Address:	3926 Washington St., Kensington	Meeting Date:	4/14/2021				
Resource:	Primary One Resource Kensington Historic District	Report Date:	4/7/2021				
Applicant:	Nancy Collins	Public Notice:	3/31/2021				
Review:	HAWP	Tax Credit:	No				
Case No.:	945073	Staff:	Dan Bruechert				
PROPOSAL:	Garage Demolition and Accessory Dwelling Unit Construction

MONTGOMERY COUNTY HISTORIC PRESERVATION COMMISSION STAFF REPORT

Figure 2: 1933 Sanborn Map showing no garage in the location of the current accessory building.

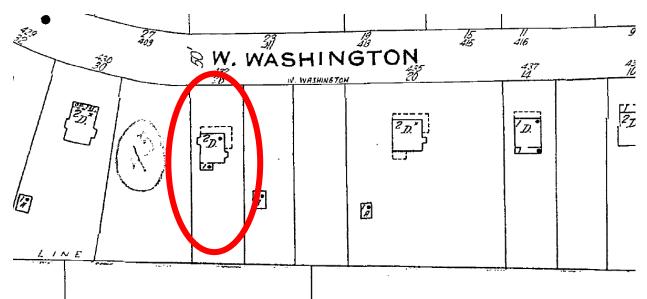
Staff finds that the existing garage is not a historic building, as shown on the map above, and does not contribute to the historic character of the surrounding district. The demolition of this structure is

appropriate under 24A-8(b)(1) and Staff recommends the HPC approve the demo.
